3	8,080 2,170	MQD-A-202	4	17,	37,840 13,580		5	4,100 4,100	6	8,040 7,810
	D01 ERNAL MODIFICATIONS KIOSK AND STOREROOM MEET CHANGES IN USEI QUIREMENTS 		TIERED	SEATING		<u>, 850 , 1,000 , 850 , </u>		G01		IFICATION FROM SLIDING GATES INGED DOORS
	STORE ROOM FFL 3.45 A: 58.73 m <sup>2</sup> EA	WIRE STORAGE CAGE WALLS	230 3,675 ACC	SH SH	CHANGE ROO L OVER BENCHE CHANGE ROO FFL 3:45 A: 45:35 m <sup>3</sup> CTI L OVER BENCHE U U U E BENCHE CHANGE ROO FFL 3:45	ACCESSIBL	E SEATING	INTERNAL FLOO	RAREA 110 RAREA 110 1,000 1,000 FIRST O FIRST O FIL FIL FIL FIL FIL FIL FIL FIL	
R	8,080					PERMEABLE PAV	E PAVING	4,100	ASINS	8,040
*1.700					2			 		THIS PLAN IS TO CONJUNCTIONS OF CONSE MOD2019
BOARD	FFL FINISHED FLOO FSL FINISHED SLAE GB# GLAZED BRICK GD GRATED DRAIN GU GUTTER HR HANDRAIL HW HOT WATER UN M METAL	3 LEVEL ME # P I PA PB RE	8 METER BOX PAINT V PAVING PLASTERBOARE F REFRIGERATOR	RL RWO RWT S	RENDER RELATIVE LEVEL (TC RAINWATER OUTLET RAINWATER TANK STEEL SCREEN SLIDING DOOR SKIRTING	) AUSTRALIAN HEIGHT DAT T	UM) VP VENT P UM) VG VALLEY W WINDO WS WHEEL	( GUTTER W	N	DOCUMENT GALEVELO( DOCUMENT MODIFICATIO REV B 16/10/2019 STAGE

**NOLAN RESERVE AMENITIES** Campbell Pde and Condamin

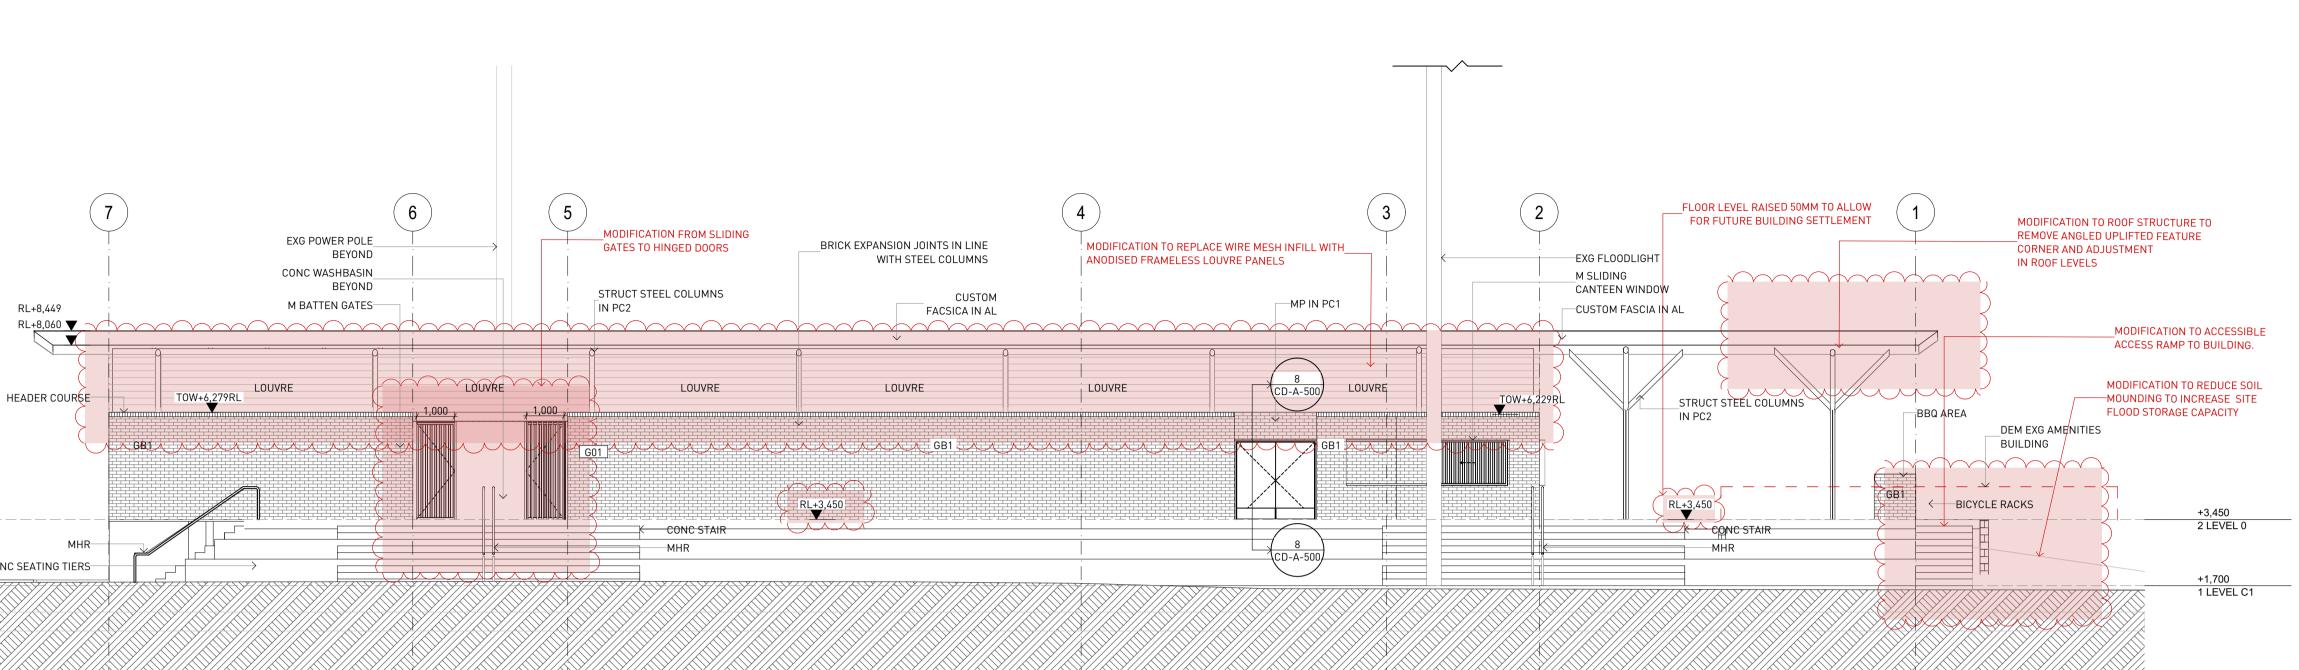
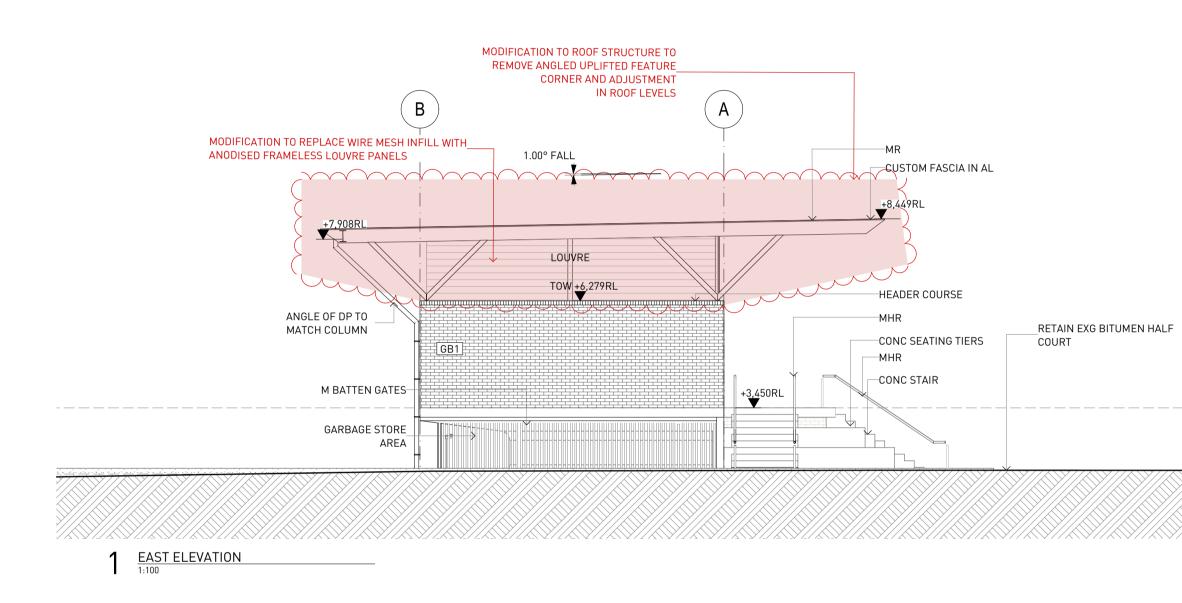
Α MODIFICATION TO ROOF STRUCTURE TO REMOVE MODIFICATION TO REPLACE WIRE MESH INFILL WITH\_\_\_\_ ANGLED UPLIFTED FEATURE ANODISED FRAMELESS LOUVRE PANELS CORNER AND ADJUSTMENT IN ROOF LEVELS  $\sim \sim \sim$ MR TO S STRUCTURE EXG FLOODLIGHT  $\longrightarrow$ CUSTOM FASCIA IN AL RL+8,055 LOUVRE FLOOR LEVEL RAISED 50MM TO ALLOW FOR FUTURE BUILDING SETTLEMENT GB1 ||r|+|+**>**||| MHR W GB1V-V +3,450RL +3,450 2 LEVEL 0 +1,700 2 WEST ELEVATION
